**MARQUETTE CITY PLANNING COMMISSION**  
**Tuesday, March 24, 2026, at 6:00 p.m.**  
**Commission Chambers at City Hall – 300 W. Baraga Ave.**

**TO:** Planning Commission  
**FROM:** Andrea Landers, Zoning Official  
**DATE:** March 11, 2026  
**SUBJECT: 01-CSD-03-26 & 02-SPR-03-26 – McClellan Meadows Site  
Condominiums (PIN: 0512412)**

**TO:** Barry Polzin Architects  
**FROM:** Andrea Landers, Zoning Official  
**DATE:** February 27, 2026  
**SUBJECT:** 01-CSD-03-26 - Review of the plan submitted dated 2-17-26 for – No address McClellan Ave (PIN: 52-52-005-124-12)

Plan Title: McClellan Meadows

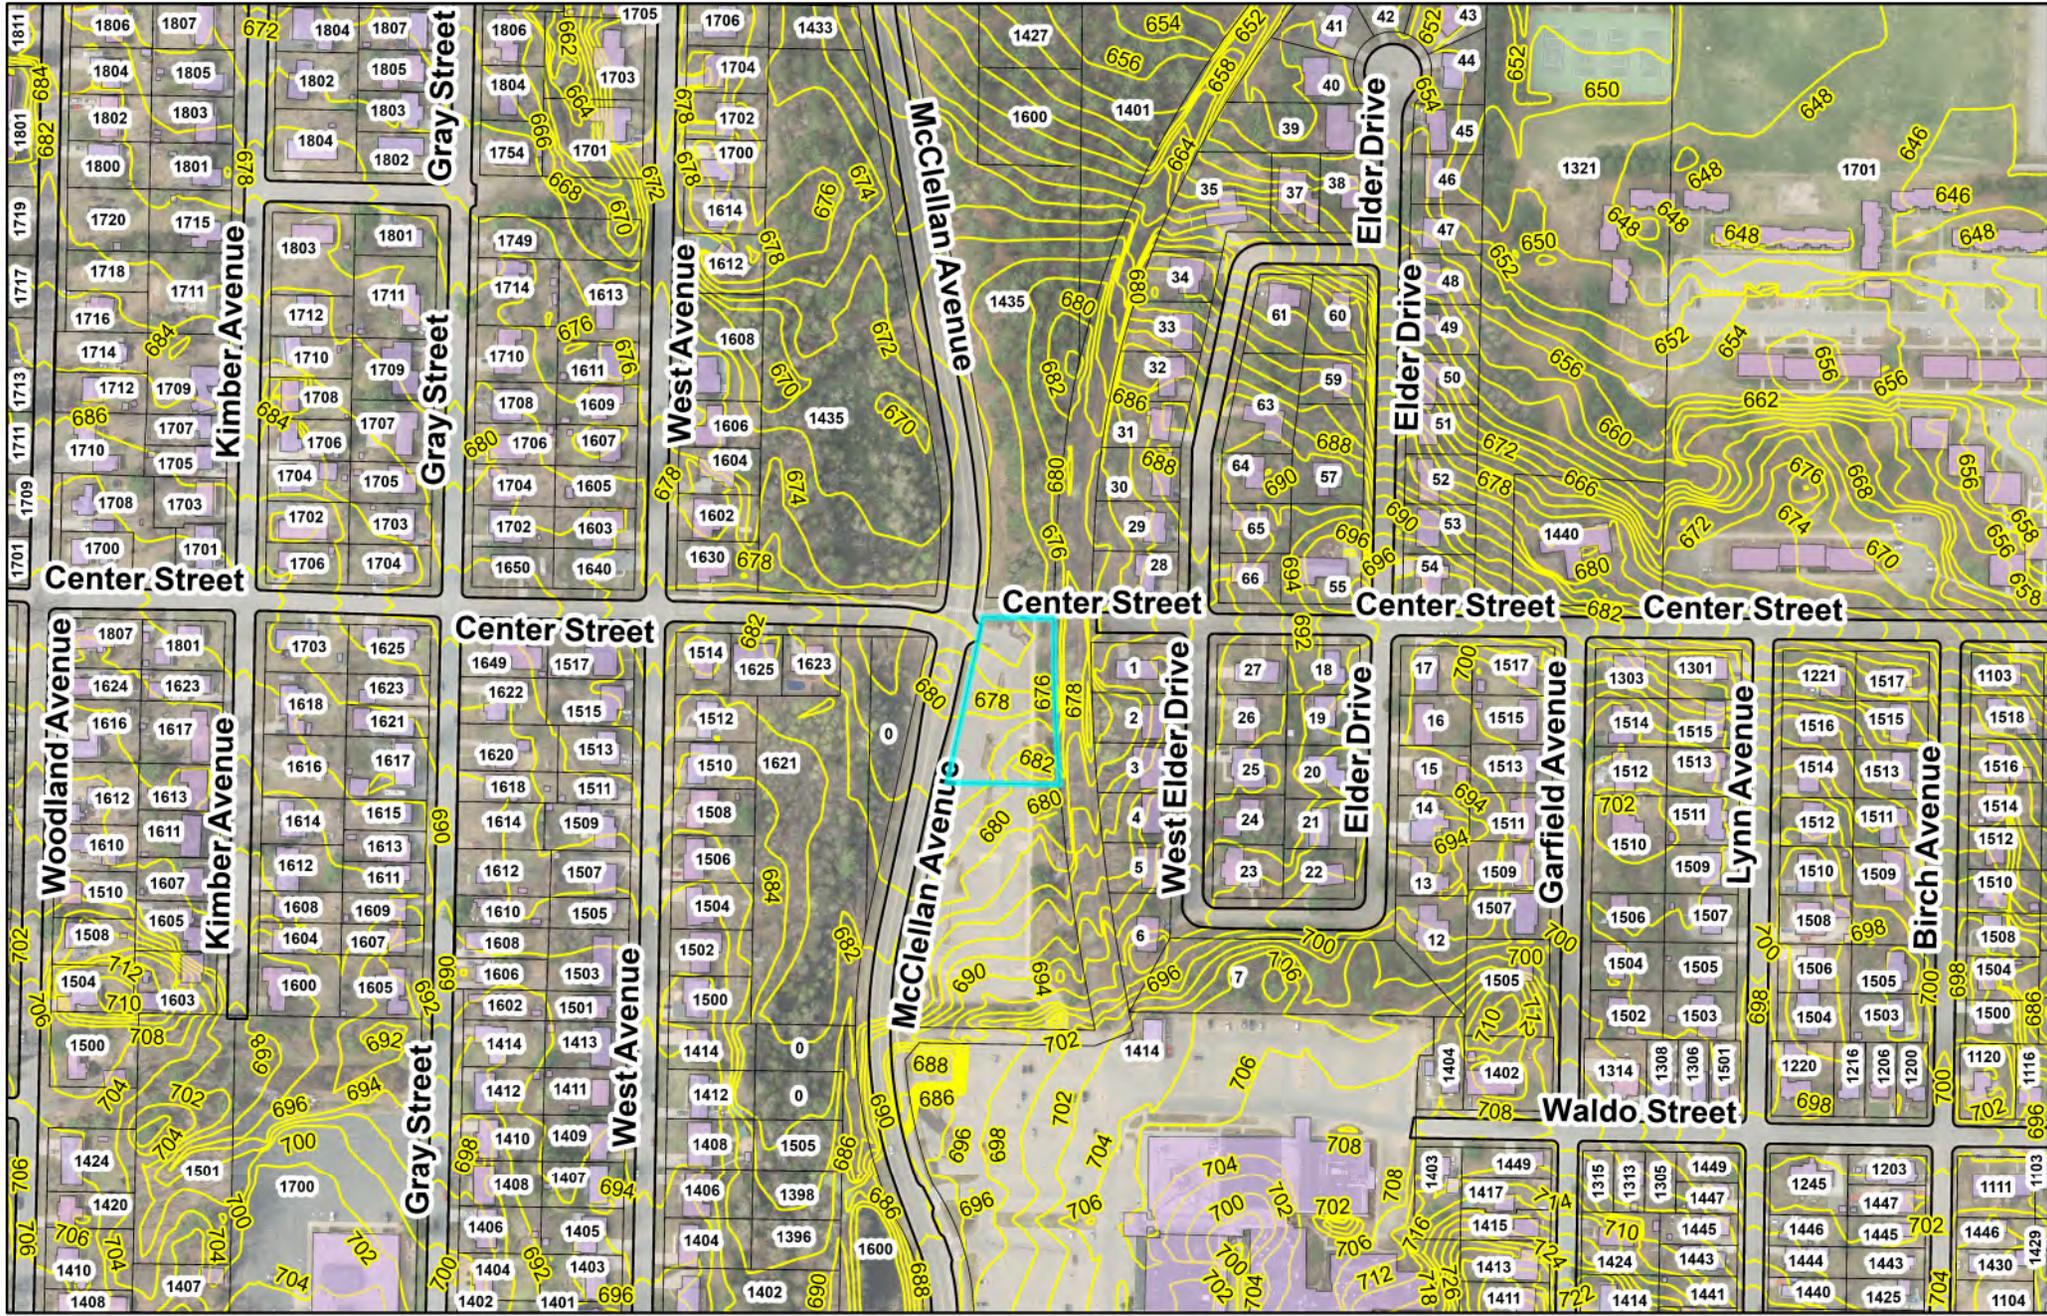
- Please confirm if the hydrant was in fact placed on the property to the south as shown on these drawings. If so, an additional utility easement will be required from that property owner. **We will confirm if placed on neighboring property that easement has been provided to the city.**
- Please see attached drawing for additional comments. **Additional comments received.**

Figure 6. Yard Terms

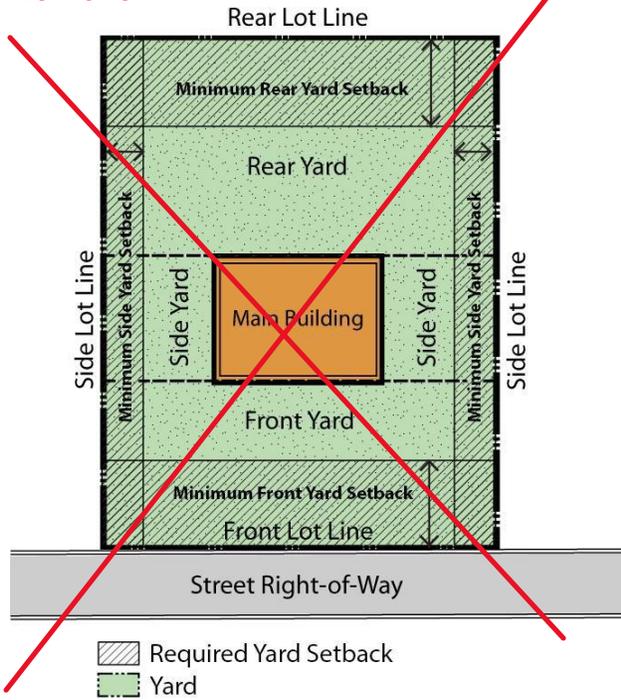
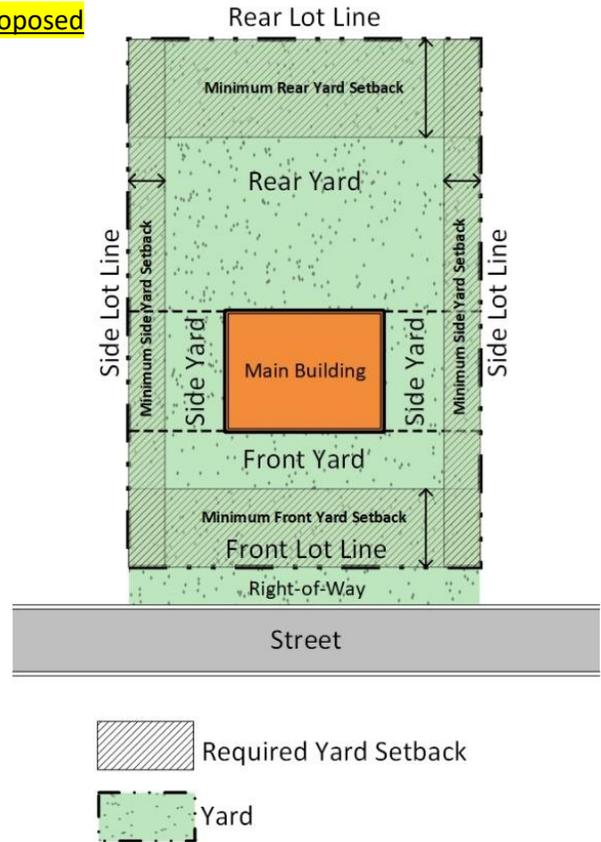
**Add a Through Lot drawing as a new Figure 8. Update the existing drawings for Figures 6 & 7.**
